RE: City of Nashville WWTP Inspections (Howard Co)

AFIN: 31-00036 Permit No.: AR0021776

V DEO		WATER	DIVISION I	NSF	PECT	ΓΙΟΝ	I RE	PORT
	ADLQ	AF	IN: 31-00036 P	ERMIT #: AR002	1776		1	DATE: 7	//27/2015
A	RKANSAS	CC	DUNTY: 31 Howa	rd	PDS	#: 0860)31		MEDIA: WN
Dep	partment of Environmental Quality	GP	S LAT: 33.91993	8 LONG: -93.861	286 L	OCATI	ION: E	ntrance	
	FACILITY INFORMAT	ION		IN	SPEC	TION II	NFORI	MATION	l
Cit	y of Nashville WWTP			FACILITY TYPE: 1 - Municipal	8402	TOR ID#: 22 S - S			
	Hwy 27 South			FACILITY EVALUATION RATIN 2 - Marginal	G:		Comp		Evaluation
	shville, AR			(-7	TRY TIME: 9:45	EXIT T			FECTIVE DATE:
	RESPONSIBLE OFFIC	CIAL		1/2//2015 0	3.43	13.	30	7/1/20 PERMIT EX	114 PIRATION DATE:
	: / TITLE							6/30/2	019
COM	rry Dunaway / Public Works Dire	Ctor		FAYETTEVILLE	SHAL	E REL	ATED:	N	
	y of Nashville			FAYETTEVILLE SHALE VIOLATIONS: N					
	ng address: 5 North Main St			INSPECTION PARTICIPANTS					
	STATE, ZIP:			NAME/TITLE/PHONE/FAX/EMAIL/ETC.:					
Na	shville AR 71852			Larry Dunaway/Public Works Director/(870) 845-4015

SUMMARY OF FINDINGS

Water Division Photographic Evidence Sheet Location: City of Nashville WWTP Photographer: Kerri McCabe Date: July 27, 2015 Time: 1022 Witness: Chip Colston Photo#: 5 Description: West aerated activated sludge basin; note excessive stored sludge (looking West).

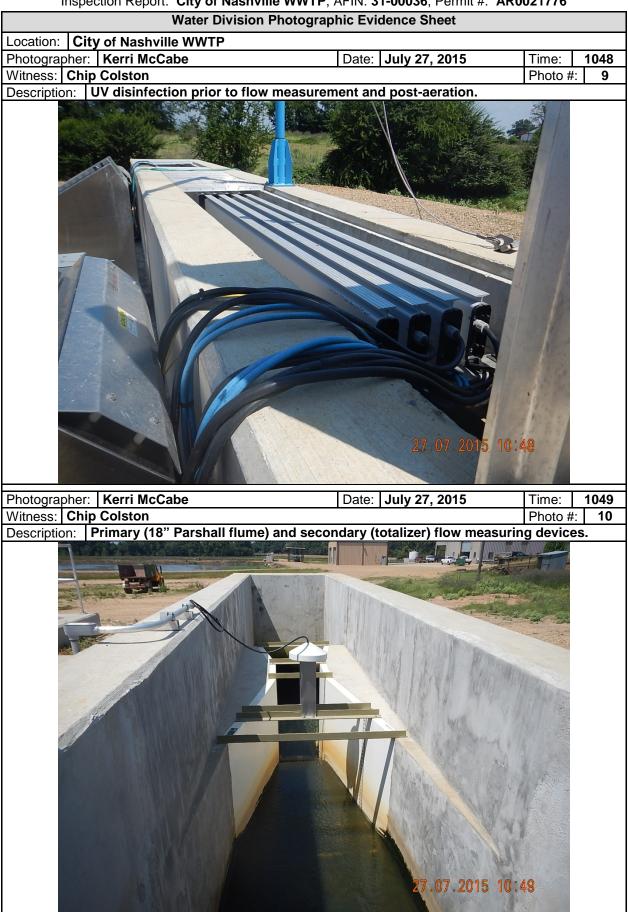
- 5.) The following items are violations of Part III, Section B.1.A. of the permit:
 - Excessive sludge is being stored in the two extended aeration activated sludge basins (formerly facultative aerated lagoons). This affects the design capacity as well as the treatment process. Some sludge has been diverted to the flow EQ basin (formerly two-cell polishing pond); however, the amount removed may not have been enough for proper treatment in the new plant.

- f. The EQ basin has been pumped down to allow for more storage capacity.
- 6. The lab bench sheet has been remodeled to reflect these problems. Times are now immediately recorded.

Photographer:	Kerri McCabe	Date:	July 27, 2015	Time:	1032
Witness: Chip	Colston			Photo #:	6

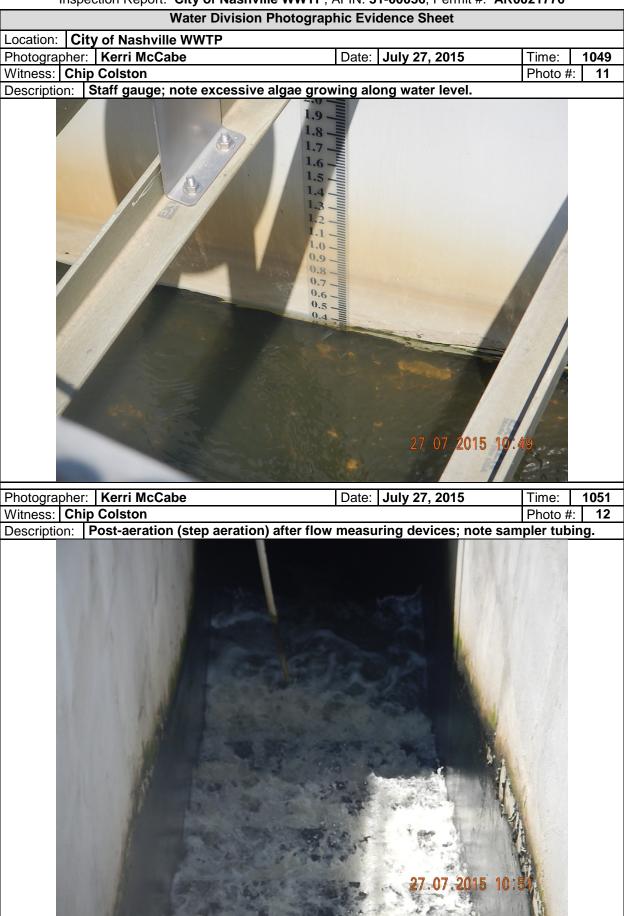
- All systems of treatment are infested with suspended algae; however, DO, TSS, and pH effluent limits do not appear to be affected by the presence of algae.

Description: Flow EQ basin; note excessive algae (green color of water).

- b. A shade cover will be installed to protect the secondary flow measuring device and electronics from the sun and rain.
- c. The algae are being addressed by adding a coagulant to aid in flocculation and settling. ADEQ has been notified.
